Merged Document Report

Application No.: PL9126

Document Filename
PLAT-Steele Addn, Block 5, Lot 63.pdf
2701 Plat Application.pdf

STEELE ADDITION BLOCK 5, LOT 63

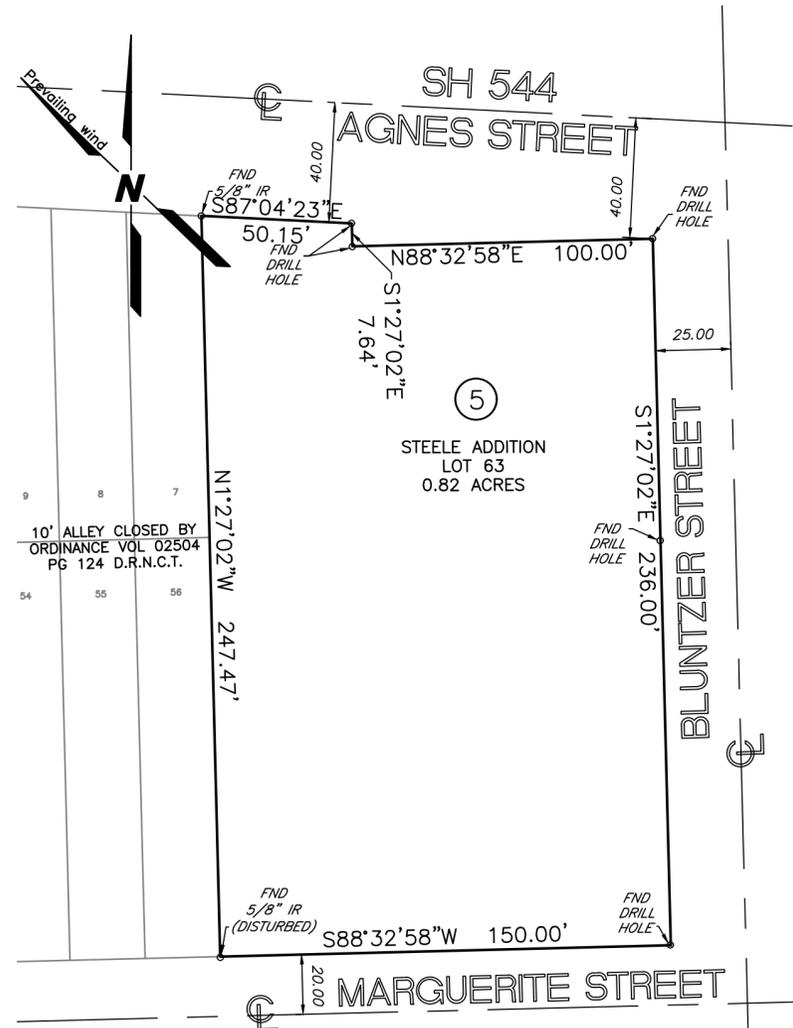
Comment ID	Page Reference	Annotation Type	Author : Department	Status	Review Comments	Applicant Response Comments
2	1	Note	Valeria Merida : DS	Closed	Peak Hour Form is missing. (As per UDC 3.1.6.B Forms)	
3	1	Note	Valeria Merida : DS	Closed	Please provide the ownership deeds for lots 5-6 and lots 57-58, Block 5.	
1	3	Note	Valeria Merida : DS	Closed	All owners must sign the application.	
4	P001	Note	Bria Whitmire : DS	Closed	Improvements Required for Recordation, per UDC 8.1.4.

Comment ID	Page Reference	Annotation Type	Author : Department	Status	Review Comments	Applicant Response Comments
					<p>A. Streets: No Sidewalks: No Lighting Plan: No</p> <p>B. Water: No Fire hydrants: No C. Wastewater: No D. Stormwater: No E. Public open space: No F. Permanent monument markers: No Please note, improvements required should be constructed to city standards, found in Article 8 and the IDM.</p>	
5	P001	Note	Mina Trinidad : DS	Closed	(Informational) Gas Department has no comments.	
6	P001	Note	Mina Trinidad : DS	Closed	<p>(Informational) CCW: Water Water construction is not required for platting (UDC 1.2.1.D & 8.2.6; Water Distribution Standards). Wastewater Wastewater construction is not required for platting (UDC 1.2.1.D & 8.2.7; Wastewater Collection System Standards).</p>	
7	P001	Note	Mina Trinidad : DS	Closed	<p>GIS: (Ziba A) Plat does not close within acceptable engineering standards.</p>

Comment ID	Page Reference	Annotation Type	Author : Department	Status	Review Comments	Applicant Response Comments
					<p>prevent overloading the capacity of the downstream drainage system.</p> <ul style="list-style-type: none"> • If the owner responsible for maintaining the permanent stormwater or water quality control fails to maintain it to TxDOT ROW standards, the owner must rectify the issue. • Any development that anticipates an increase in existing traffic generation may be required to conduct a traffic study. The necessary improvements identified in the traffic study may need to be constructed by the developer, based on TxDOT's discretion and approval, prior to the access connection being establish. 	
12	P001	Note	Mina Trinidad : DS	Closed	<p>TxDOT: (Lucio R) The small window map in the top right corner, showing the "SITE" in grey, is in the wrong block, S. of Marguerite St. instead of S.of Agnes St.</p>

Comment ID	Page Reference	Annotation Type	Author : Department	Status	Review Comments	Applicant Response Comments
19	P001	Note	Mina Trinidad : DS	Closed	Change Michael Dice signature block to "Director"	
20	P001	Note	Mina Trinidad : DS	Closed	Change Planning Commission signature to "Cynthia Salazar-Garza" and "Chairperson"	
21	P001	Note	Mina Trinidad : DS	Closed	Increase street text within site map.	
22	P001	Note	Mina Trinidad : DS	Closed	(Informational) AEP Distribution has no comment.
